Access Compliance Report

Public Rights-of-Way

Intersection ID: 10030329	Main Street: LELA_AV	Cross Street: N/A	Location: N/A
ADA ID: CD17F161C40D	Ramp Type: Perp	Initial Pass/Fail: Fail	Overall Compliance: No
			Severity Score: 13.75

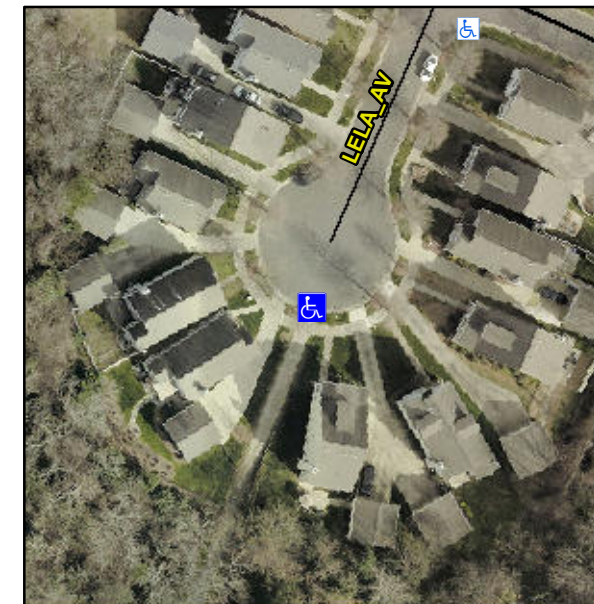
Not Found, R304.2.2

Compliance	Description	Data	Compliance	Description	Data
N/A	Ramp Length (in)	70.0	No	Ramp Slope (%)	9.8
Yes	Ramp Width (in)	58.0	Yes	Ramp XSlope (%)	2.2
N/A	Flare Type LT	N/A	N/A	Flare Type RT	N/A
N/A	Flare Slope LT (%)	N/A	N/A	Flare Slope RT (%)	N/A
N/A	Flare Traversable LT?	N/A	N/A	Flare Traversable RT?	N/A
N/A	Landing Length (in)	N/A	N/A	DWS Provided?	N/A
N/A	Landing Width (in)	N/A	N/A	DWS Contrast?	N/A
N/A	Landing Slope (%)	N/A	N/A	DWS Length (in)	N/A
N/A	Landing X Slope (%)	N/A	N/A	DWS Full Width?	N/A
N/A	Landing Curb? (Y/N)	N/A	N/A	DWS Offset (in)	N/A
N/A	Shared Landing?	N/A			
N/A	Gutter Ponding?	N/A	N/A	Gutter Slope (%)	N/A
N/A	Gutter Lip Ht (in)	N/A	N/A	Gutter X Slope (%)	N/A
N/A	Painted X Walk1?	No	N/A	Painted X Walk2?	N/A
	X Walk 1 Direction	To N		X Walk 2 Direction	N/A
N/A	X Walk 1 Width (in)	N/A	N/A	X Walk 2 Width (in)	N/A
	X Walk 1 Slope (%)	1.9		X Walk 2 Slope (%)	N/A
	X Walk 1 X Slope (%)	2.8		X Walk 2 X Slope (%)	N/A

Remove & Replace Entire Ramp.
